**SUBJECT:** CUP 03-147

**KOHL'S COMMERCIAL DEVELOPMENT  
TRAFFIC IMPACT STUDY (MAY 19, 2005)  
CONDITIONAL USE PERMIT 03147  
SAN GABRIEL AREA**

**KOHL'S COMMERCIAL DEVELOPMENT  
TRAFFIC IMPACT STUDY (FEBRUARY 20, 2004)  
ADDENDUM (MARCH 23, 2004)  
CONDITIONAL USE PERMIT 03147  
LOS ANGELES COUNTY**

### **CONDITIONAL USE PERMIT NO. 03-147**

**FIGURE 13**  
**CUMULATIVE MITIGATION**  
**LANE CONFIGURATIONS**  
Kohl's Commercial Development Project

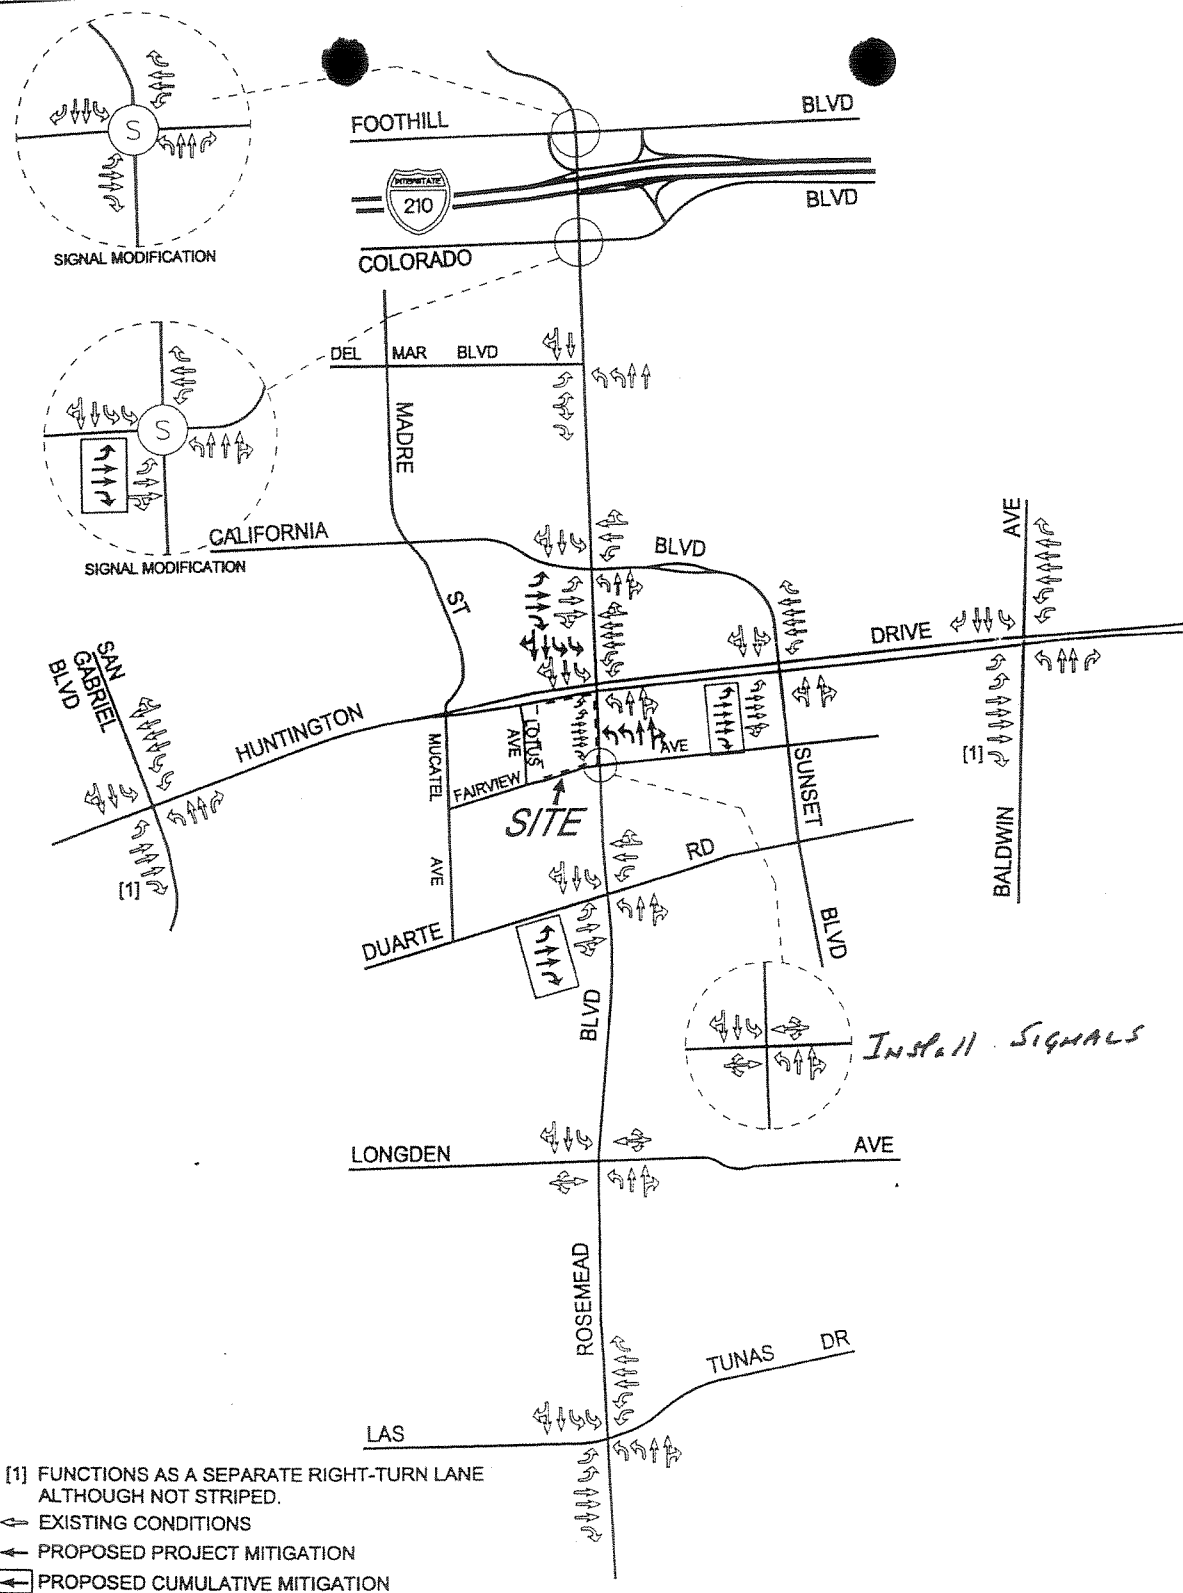
The traffic analyses in the previous section determined that development of the cumulative development projects is anticipated to result in significant impacts at four intersections. The recommended traffic mitigation program developed for these projects includes physical roadway improvements and funding of traffic signal improvements. The following cumulative mitigation measures, as shown in Figure 13, are proposed:

#### Rosemead Boulevard and Fairview Avenue Signalize intersection.
